SERVICE LETTER

No. 718

Subject: Bendix Magneto Bulletin No. 566 -- reference attached Avco Lycoming Service Bulletin No. 373, dated March 22, 1974.

SUBJECT: S-1200 Distributor Block and Gear Change

Figure 1.

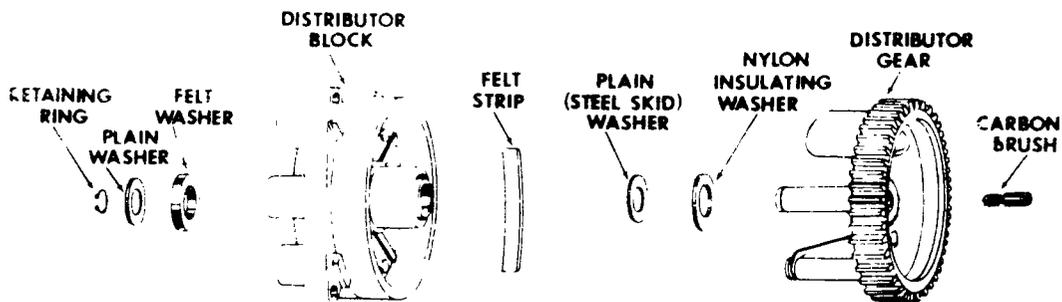
Detailed Instructions:
It has been found that the addition of a nylon insulating washer and steel skid washer between the distributor gear electrode and the block bushing, as shown in figure 1, reduces the possibility of deterioration of the lubricant and possible seizure of the parts.

Once modified, the distributor block can be used only with a gear having the nylon and steel washer installed over the shaft as shown in figure 1.

Assemble large distributor gear, nylon and steel washers to new or reworked block as follows using figure 1 as a guide.

2. Slide nylon insulating washer 10-391309 and plain washer 10-391511 onto gear shaft.

3. Lubricate inside of bronze bushing with a light film of Bendix Distributor Block Lubricant. ** Insert shaft of gear through distributor block and position plain washer on shaft. Using the 11-3071 Retaining Ring Pliers, install retaining ring on shaft. Rotate gear to insure there is no interference between gear electrode and block electrodes.

Figure 2

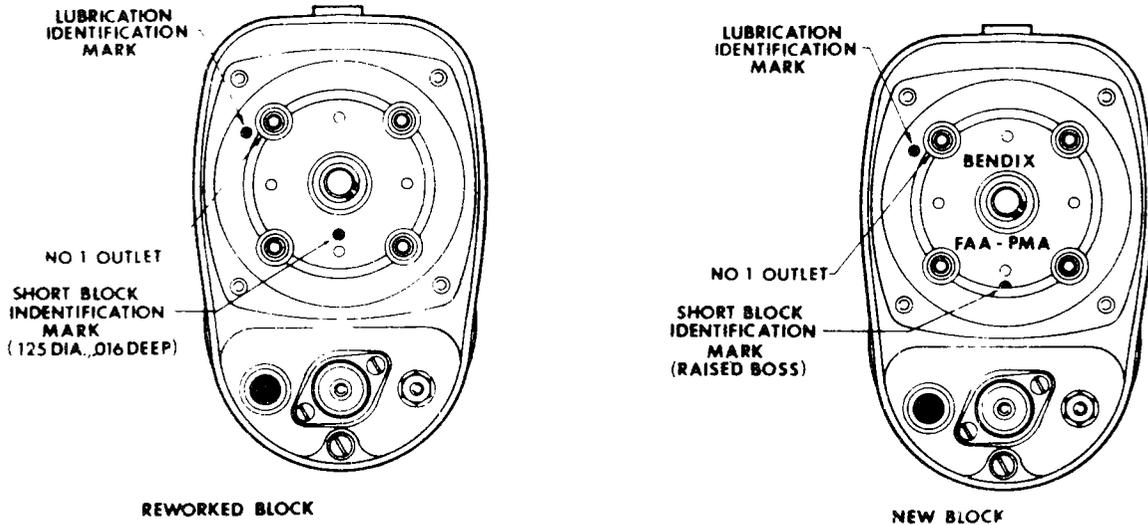
The addition of the washers make it necessary to shorten the gear end of the bushing and block. New production blocks incorporating the change are identified by a raised

boss between the high tension towers at the six o'clock position and molded in letters as shown in figure 2. Reworked blocks are identified by a drill point indentation in the same location. New and reworked blocks both have different part numbers from the current (old) block. See Table 1.

- Slightly chamfer all corners of reworked surfaces
- Identify reworked blocks by drilling a flat bottomed hole .125" diameter and .016" deep in the six o'clock position as shown in figure 2
- Blow out chips and foreign matter
- Clean dielectric surfaces of distributor block thoroughly of all grease and coating by rinsing in a container of trichlorethylene. Repeat cleaning process until all coating is removed. Dry in a ventilated oven at 160° for ½ hour minimum.
- Impregnate bronze bushing and coat distributor block as follows:

a. If distributor block is not marked with a raised boss or drill point indentation to the left and adjacent to the No. 1 high tension tower (see figure 2), remove old lubricant from bushing as follows.

(3) Identify distributor block by drilling flat bottomed indentation .125 inch diameter and .016 inch deep located as shown in figure 2.

Figure 3.

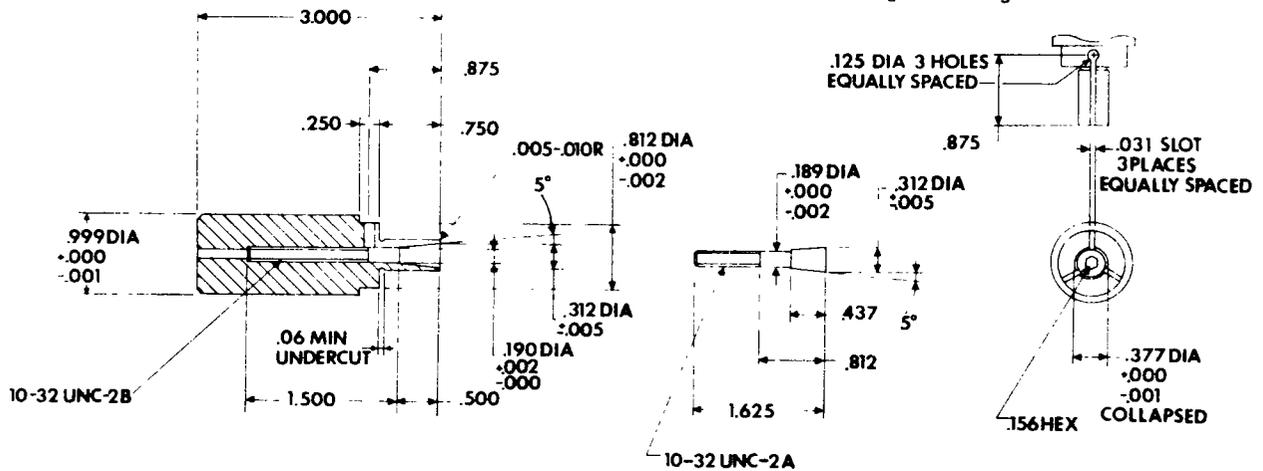
- Clean and inspect to insure distributor block is suitable for continued use before reworking
- Fabricate an expanding arbor lathe fixture as shown in figure 3. (Similar arbors may be purchased from industry machine tool supply houses.)
- With arbor in lathe, slide distributor block over arbor, high tension outlet tower side first, until block bushing bottoms on arbor shoulder. Tighten arbor expansion screw until block is held securely for turning operation
- Use a suitable cutting tool and turn so that overall length of bushing is $1.200 + .005 - .000$ inch as shown in figure 4. (A Carbaloy tipped tool is recommended.)
- Using same cutting tool, turn dielectric material of block so that resulting surface is .015 inch below end

Expanding arbor lathe fixture. (See figure 3).

Figure 4.

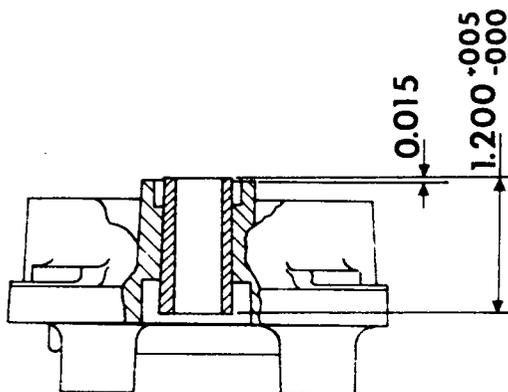
of reworked bushing. See figure 4
